Project M-32

SUBJECT: REQUEST FOR DOE DOCUMENTS - WASTE SOLIDIFICATION SYSTEMS
(WSS) ELEMENT (TAC NO. L30616)

SEISMIC / TORNADO ANALYSIS REVIEW FOR THE VITRIFICATION FACILITY AT WEST VALLEY

Figure 3-3. VF stick model used by Dames & Moore (Gates, 1993)

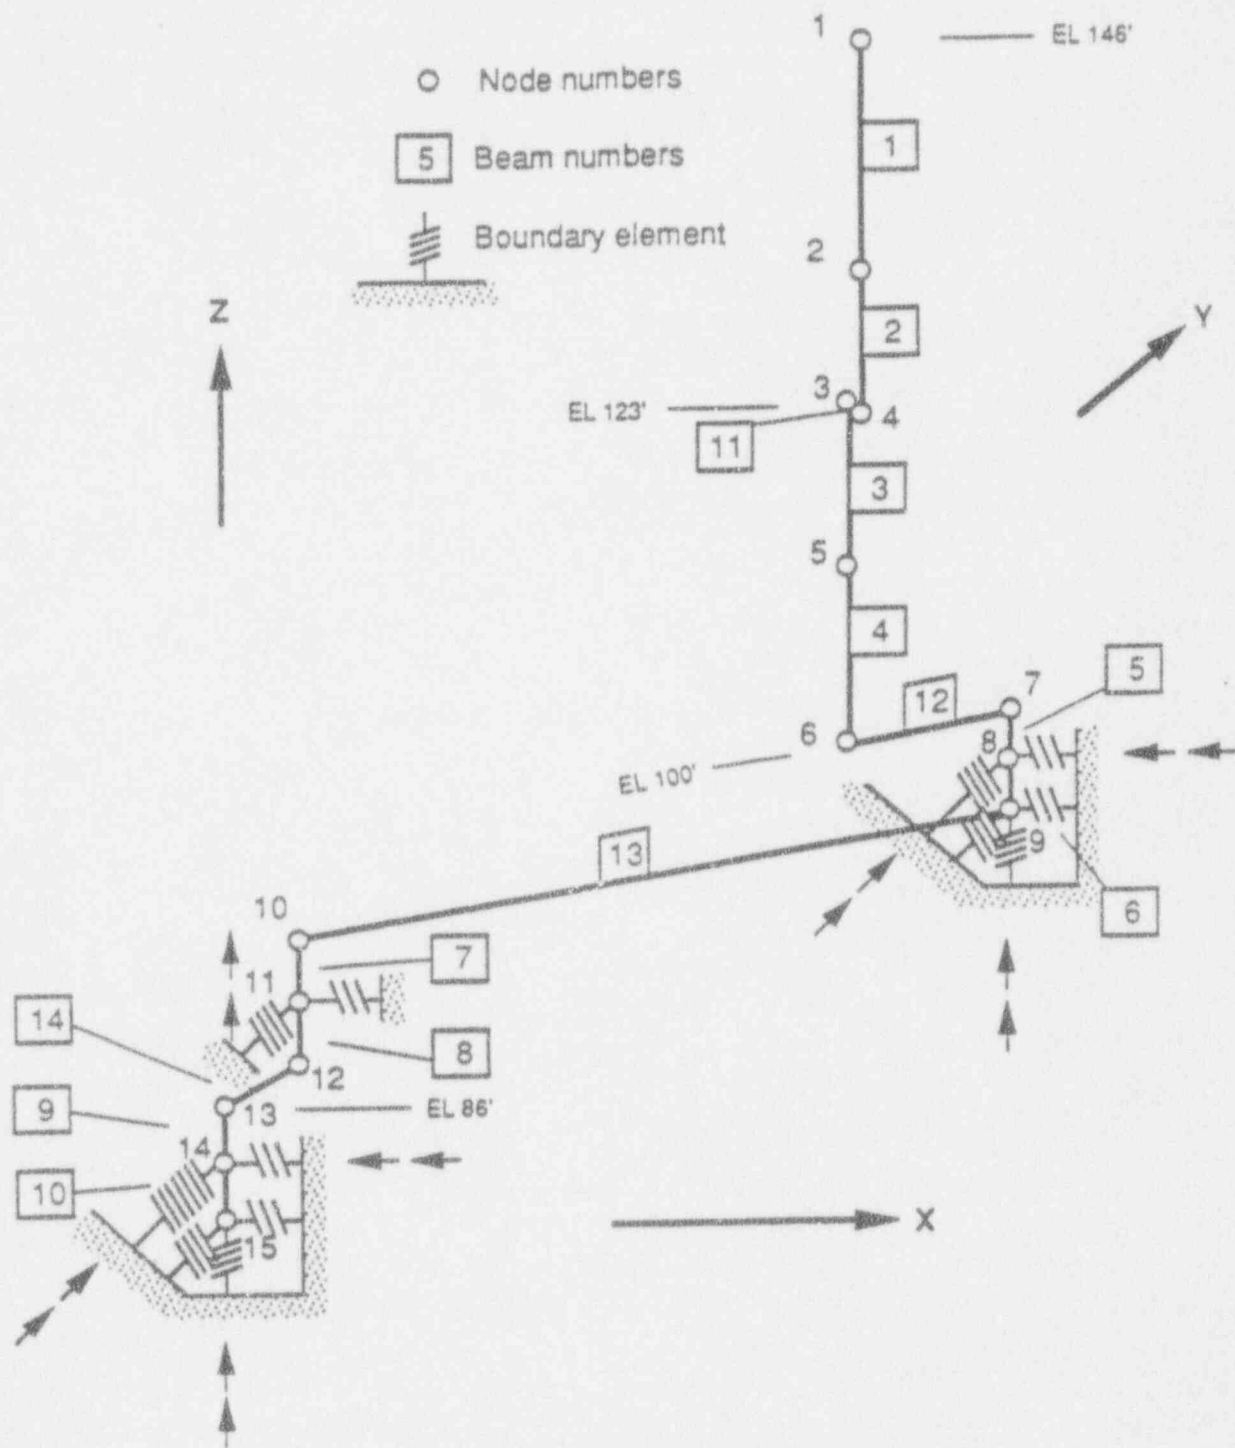
The alternative procedure used in the original analysis, and that performed by Dames & Moore (Gates, 1989b), is to idealize the soils utilizing boundary elements consisting of springs and dampers. For the 3D stick model (Figure 3-3), boundary elements were used at three different physical locations. At two of the locations, boundary elements are placed at different elevations to account for embedment of the foundation. The source of the values used in determination of the stiffness and damping values used in this model are not given. It appears that they are based on the simplified approaches similar to those given by Das (1983), Novak (1974), and Veletsos and Meek (1974). From the discussions given in the various documents, it is not apparent whether a linear or nonlinear boundary element was utilized.

(Figure 3-3). The results presented are in terms of modal frequencies, peak displacements at various locations, elevated response spectra, and the forces and stress in the elements. The response spectra indicate a primary response of 5 to 7 Hz, corresponding to the first natural frequency of the VF cell. Under earthquake loading, the margins of safety for structural yield or failure range from 3 to 6, except for the roof hatch, for which the margin of safety was 1.5. Reduction of the soil damping from 20 percent to 10 or 15 percent could lower these by as much as a factor of 2. This could result in margins of safety less than 1.0. Therefore, resolution of the soil damping values is critical for resolution of this open issue.

For the VF primary structure using the 3D FEA stick model (Figure 3-3), results were presented in Gates (1993). Results are in terms of modal frequencies, peak displacements at various locations, elevated response spectra, and forces and strains in the elements. The response spectra indicate a primary response at 5 to 7 Hz, corresponding to the first natural frequency of the VF cell, which is consistent with reinforced concrete structures of this geometry.

Figure 3-4. Dames & Moore FEA model of reprocessing plant guyed stack (Gates, 1993)

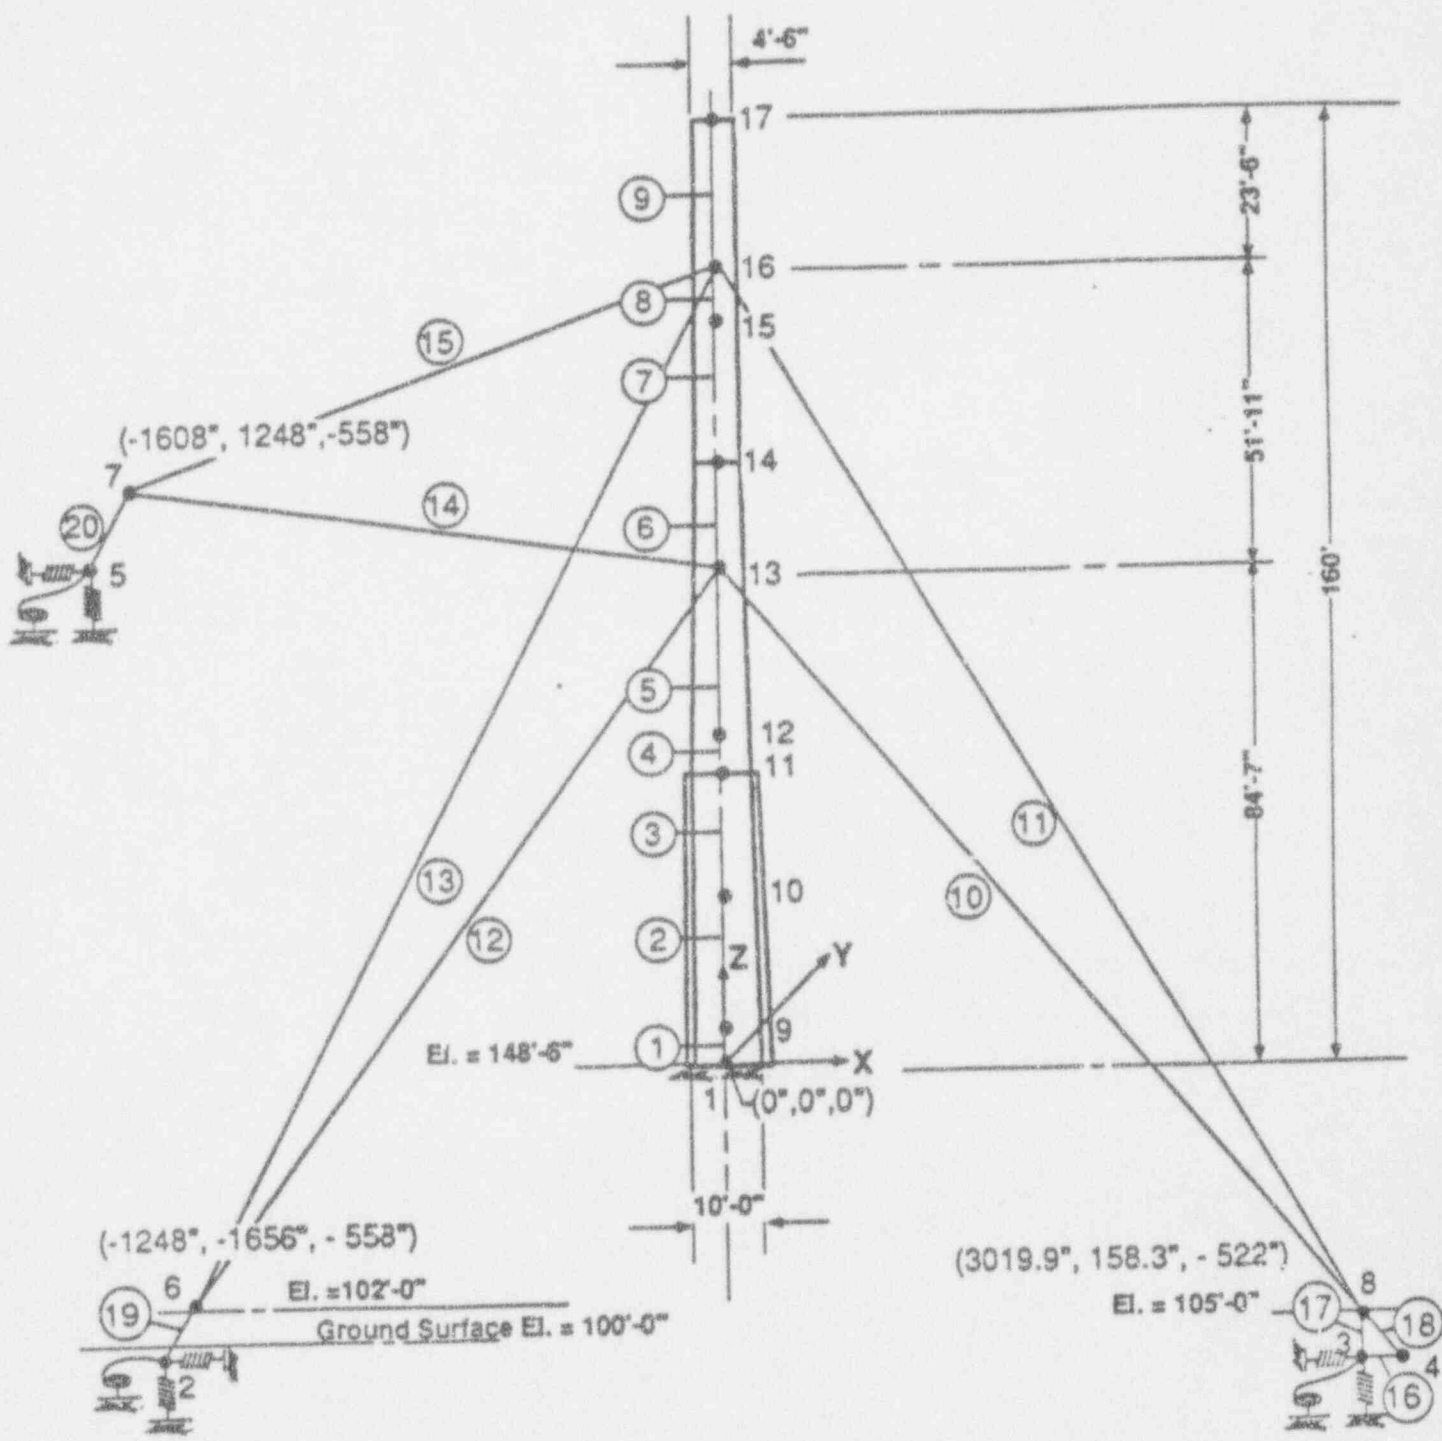
In the modeling of the stack, it was assumed that the base was fully restrained. For a slender system of this type, it is difficult to obtain a moment restraint at the base, even with the expanded diameter and the addition of gunite to the lower portion of the stack. Realistically, the first mode of the system will be below the calculated 2.34 Hz when the base compliance is taken into account. The best way to verify the model is to take field measurements under ambient vibrations to determine the lowest modes. For this analysis, a 3D FEA beam model was utilized (Figure 3-4).

The response spectra used to define the input into the stack was based on an earlier analysis of the Reprocessing Plant and is dominated by the resonant response of the stack. By matching the calculated first mode of the stack to the stack base response spectra, the current model of the stack is forced to correspond in frequency to the earlier model. The net effect is to produce a conservative analysis.

The behavior of the existing 160-ft Reprocessing Plant Ventilation Stack (Figures 3-4 and 4-2) was analyzed under extreme environmental loads that include wind, tornado, and earthquake. The intent of the study was to realistically assess the collapse potential of the stack and the risk that such collapse might pose to the VF. Even if this failure were to occur, the possibility of any damage to the VF is remote. Although the resulting margins of safety are given, no calculations are shown supporting these. It would be appropriate to obtain some measured data on the dynamic characteristics of the stack, as well as major elements in the VF, for verification of the analytical models.

Figure 3-6. FEA of canister storage racks and waste header guide used by Dames & Moore (Gates, 1993)

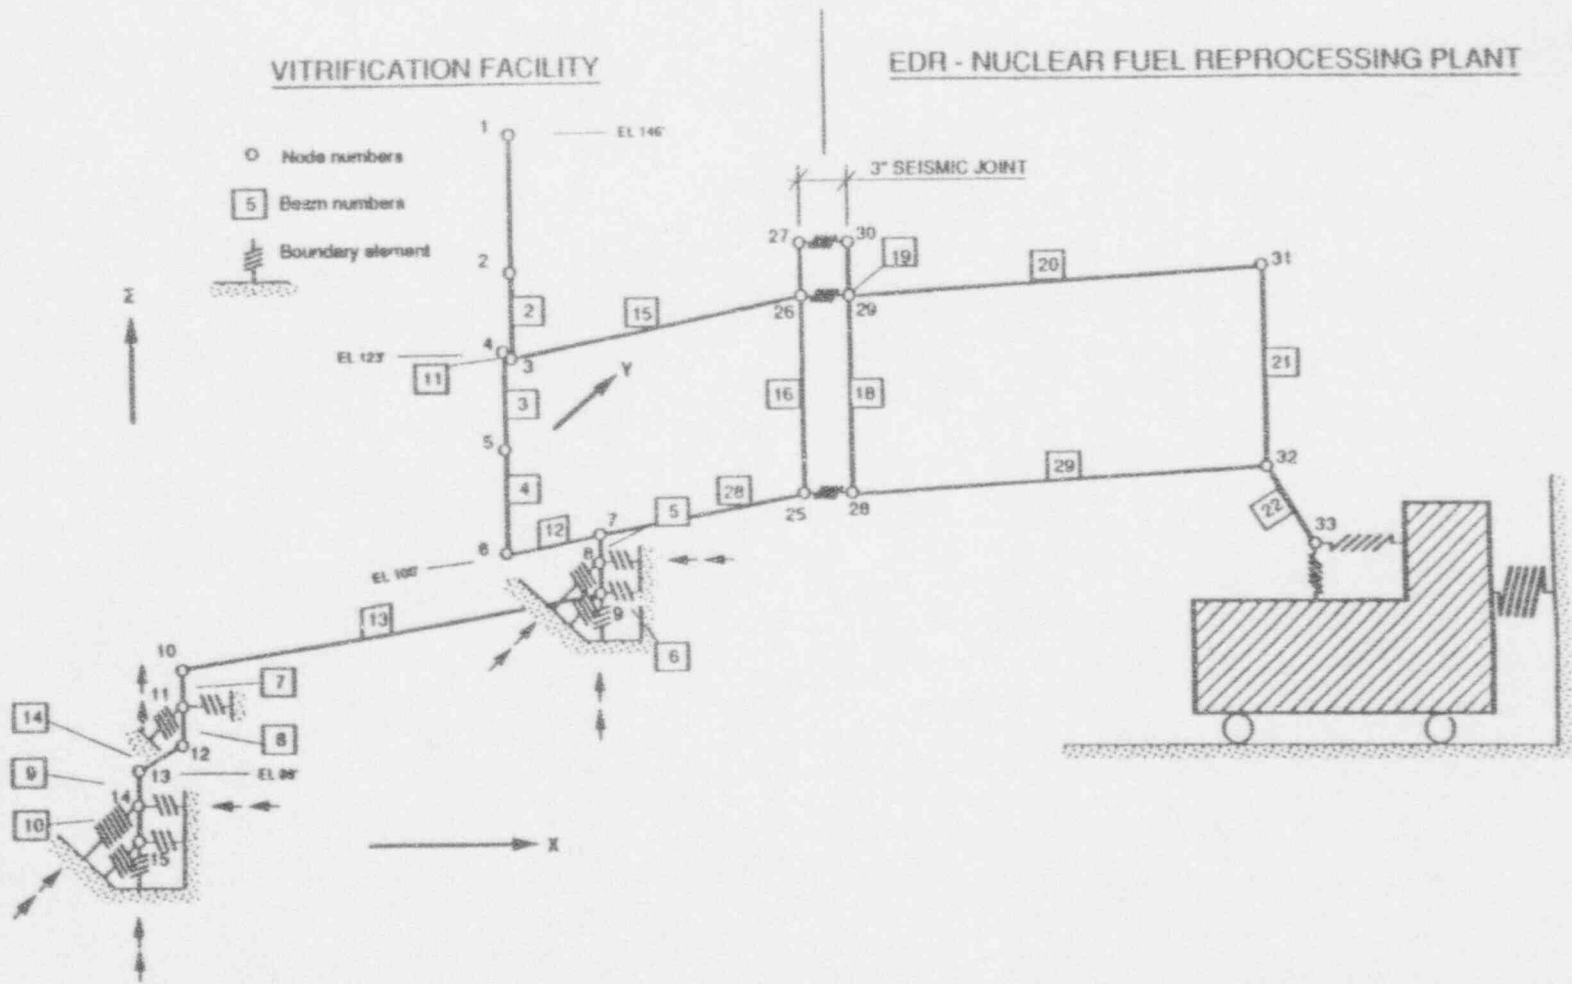
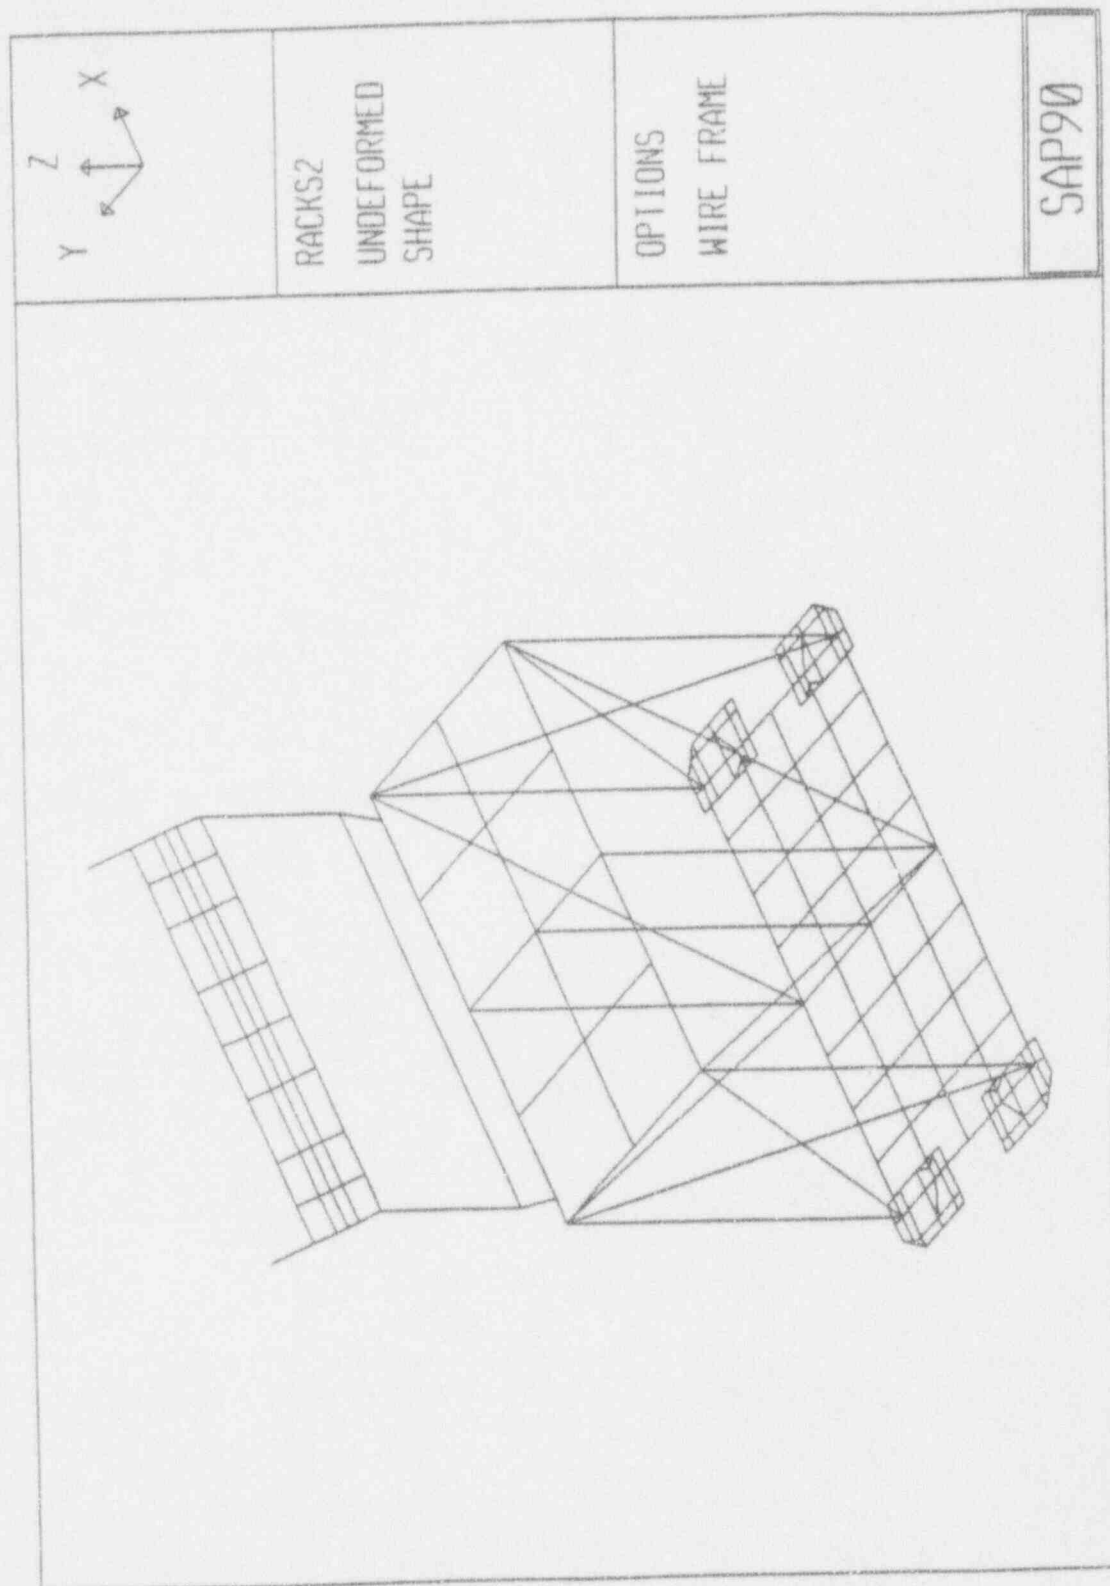
- Melter Supports (Overview with no results),
- Canister Storage Rack and Waste Header Guard (Overview with mode shapes. Stress ratios less than 0.66) Figure 3-6
- Overhead Coolers (Overview with no results)
- Overhead Cranes (Verbal indication of possible uplift)
- HVAC System (Overview of system)

Figure 4-1. Geometry of the shield windows (Gates, 1993)

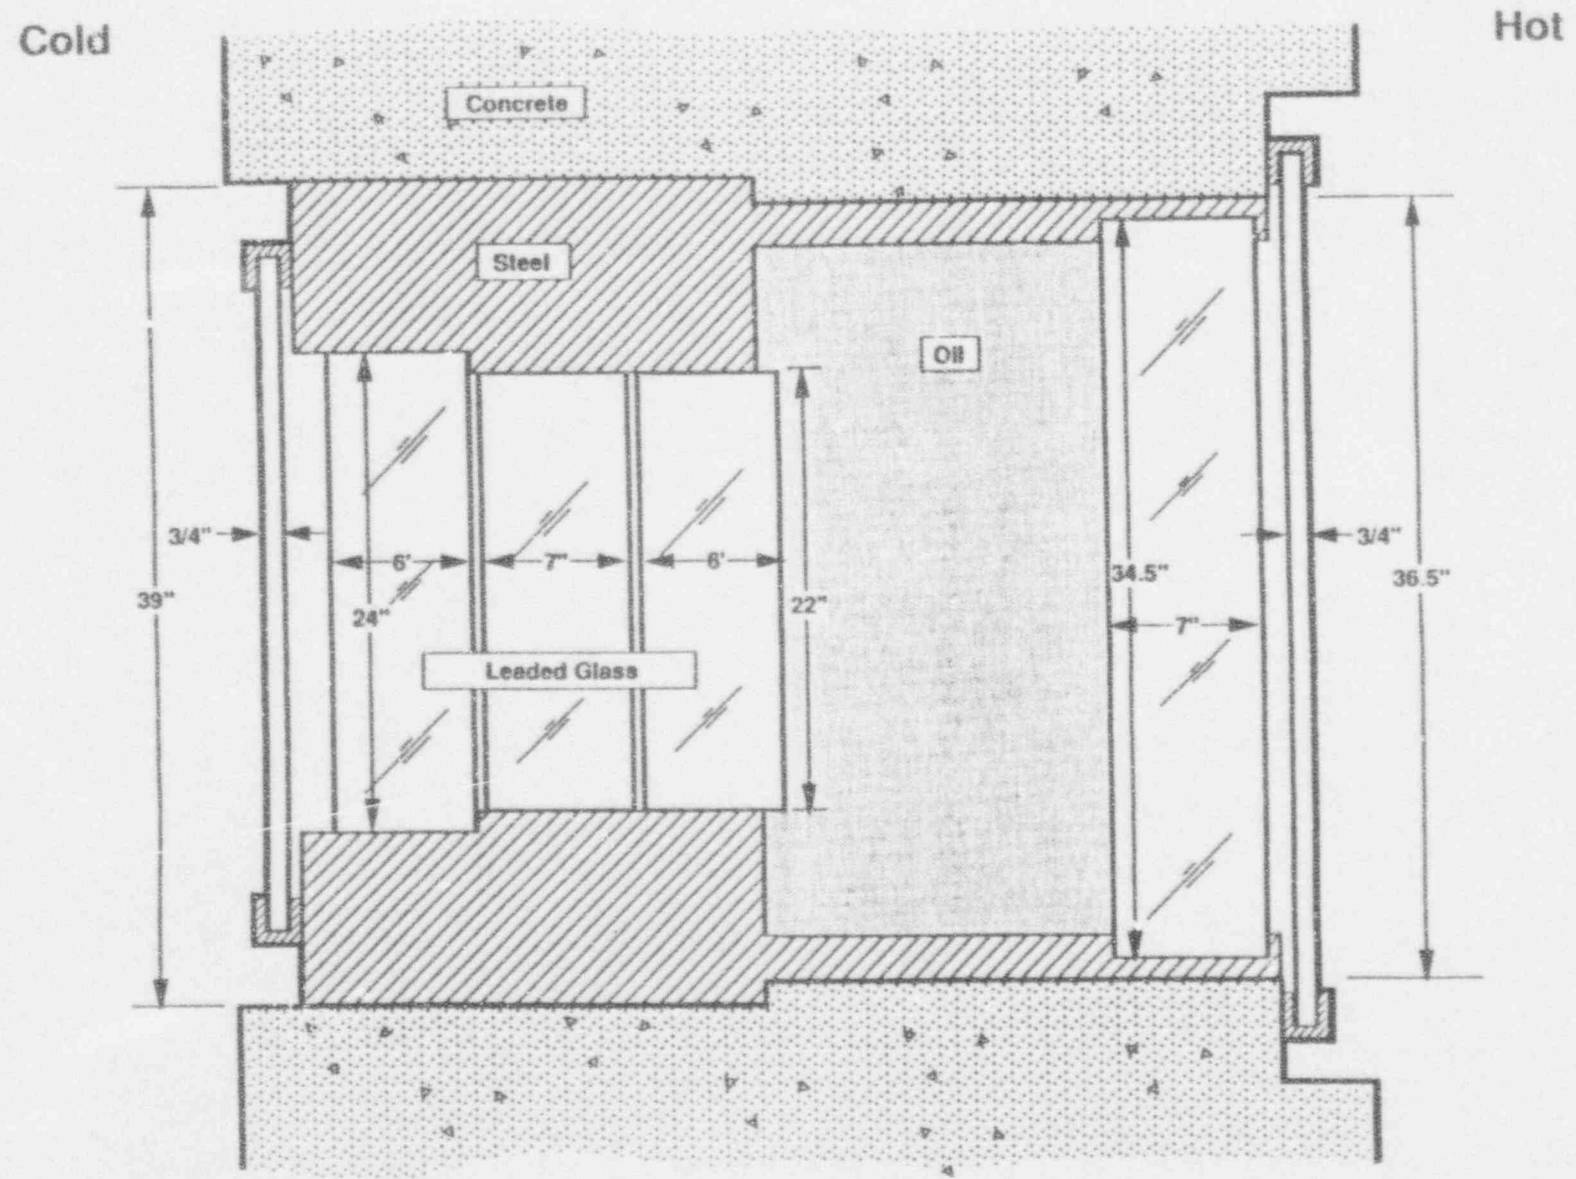
The shield windows are considered a weak element in the primary passive containment system when subjected to impact by a tornado-driven missile. The basic geometry of the window is shown in Figure 4-1. It consists of multiple layers of leaded glass supported in

For the shield windows, the approach taken was to assume that penetration did occur and determine the level of leakage. If the leakage rate was acceptable then the design was considered to be acceptable. This procedure was discussed in detail in Section 4.
